APPLICATION FOR FULL PLANNING PERMISSION  
DELEGATED REPORT

| APPLICATION REFERENCE:   | PL/2026/02387                                                        |
| SITE ADDRESS:            | Former Town Bridge Garage, Wicker Hill, Trowbridge, BA14 8LA         |
| DEVELOPMENT DESCRIPTION: | Installation of 2 No. roof mounted condenser units to west elevation |

*Proposed Elevations*

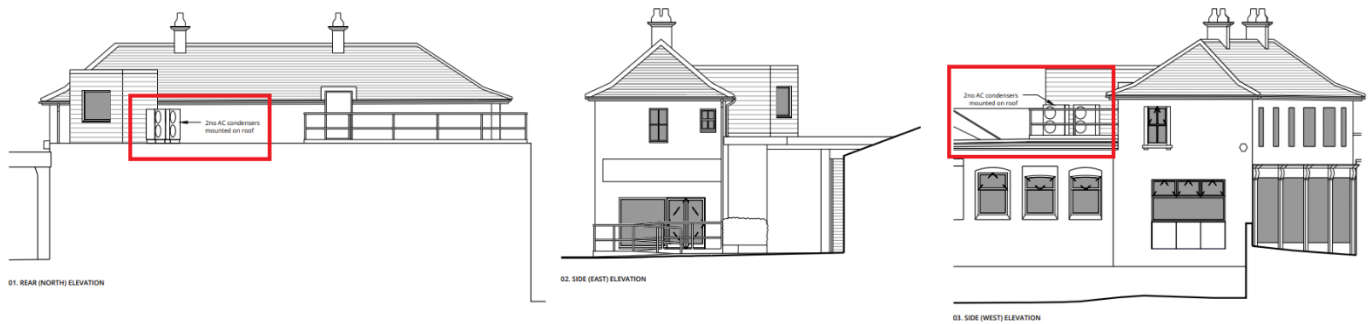
The proposal comprises the installation of 2 no. small-scale condenser units at roof level on an existing commercial building. By virtue of their limited size, utilitarian appearance and siting below the roofline and behind the main building mass, the units would not be visible from the public realm, including views along Wicker Hill. As such, the development would have a negligible visual presence. Even if glimpsed in wider views, such equipment is characteristic of commercial premises and would appear entirely consistent with the established commercial character of the surrounding area, which includes a range of service infrastructure associated with town centre uses. The proposal would not alter the form, scale, massing or architectural composition of the host building and would preserve the character and appearance of the wider street scene.
